CONTINUING ELIGIBILITY INSPECTION (CEI) REPORT
FOR HURRICANE & SHORE PROTECTION PROJECTS
Honolulu Engineer District
CEPOH-EC-T

1. Project Name: Ofu Shore Protection Project (SPP)

2. Date of Inspection: May 22, 2002

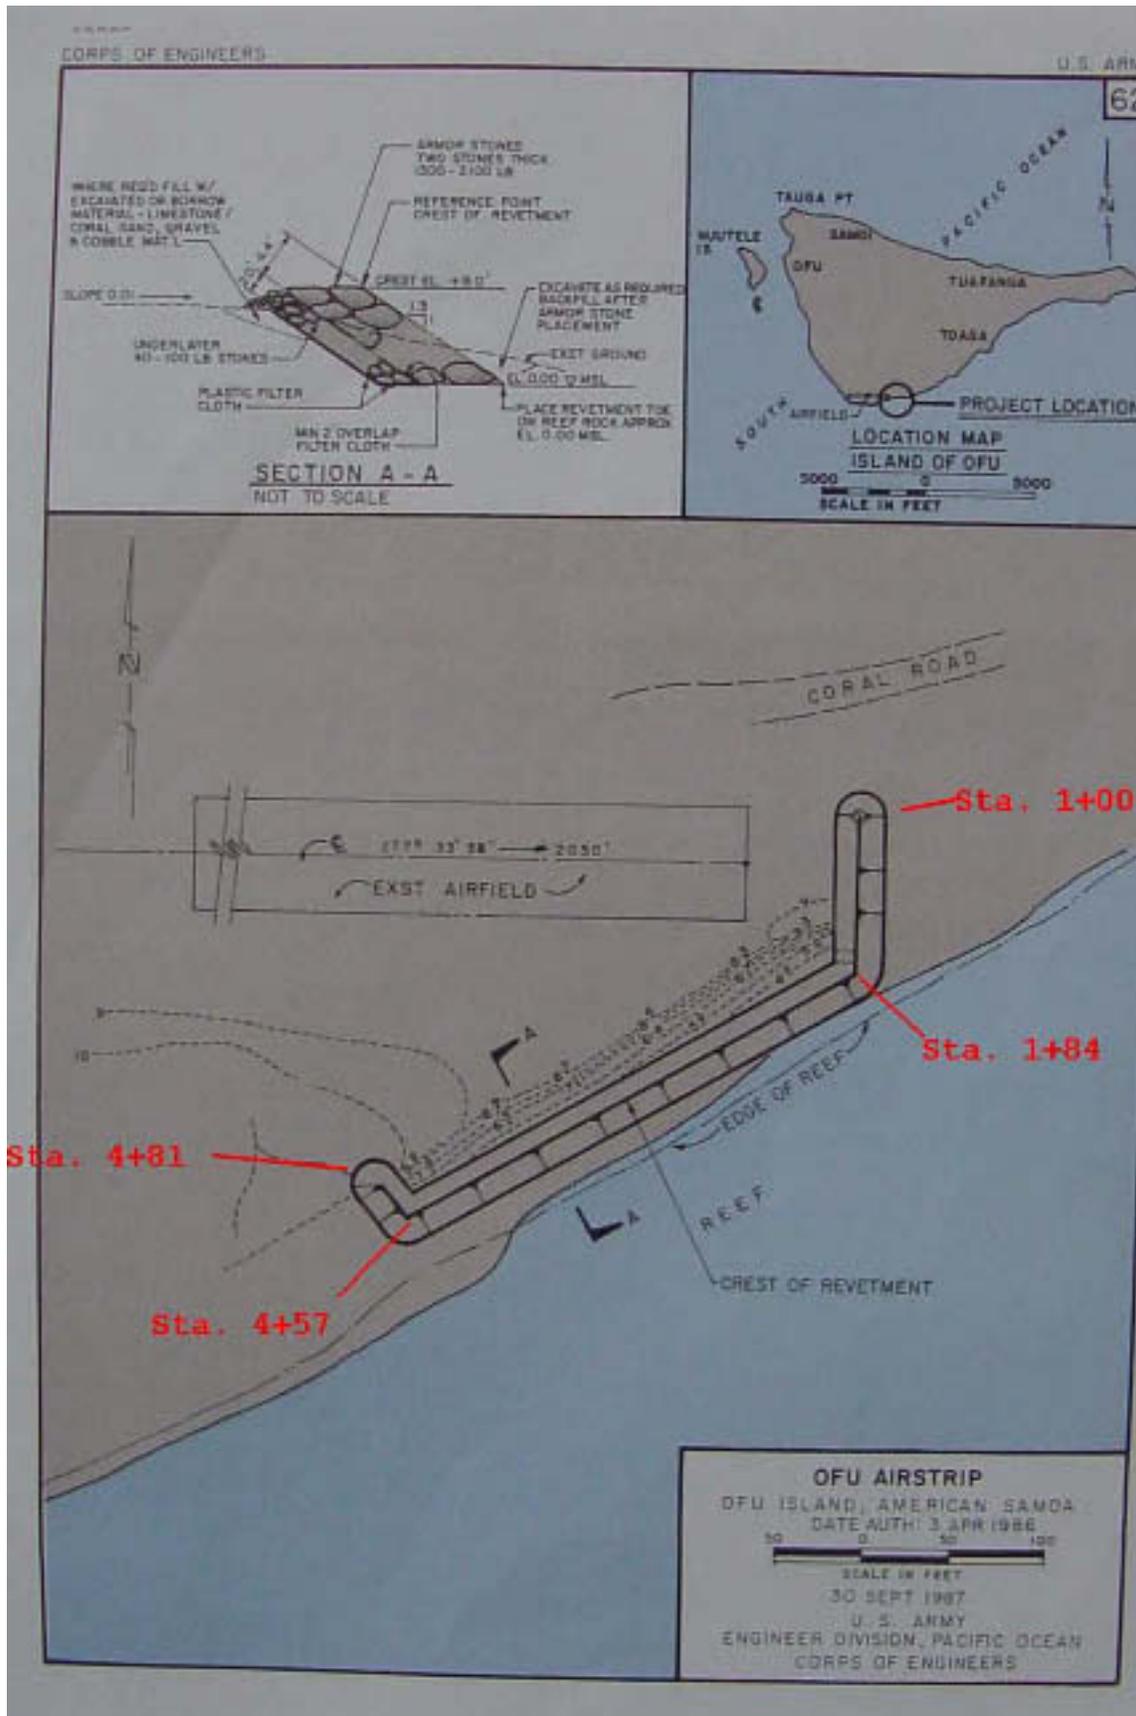
a. Sta. 1+00 - 1+25, vegetation (vines) has established on the armor stones; herbicide and remove.

b. Sta. 1+84, Overview of stones adjacent to eastside of the project, photo for reference.

c. Sta. 1+84, Overview photo for reference.

d. Sta. 2+75, Monitor this area for movement and settling.

e. Sta. 3+00, Overview facing East, photo for reference.

f. Sta. 4+57, Overview facing East, photo for reference.

- g. Sta. 4+60 to Sta. 4+81, Remove vegetation from structure.
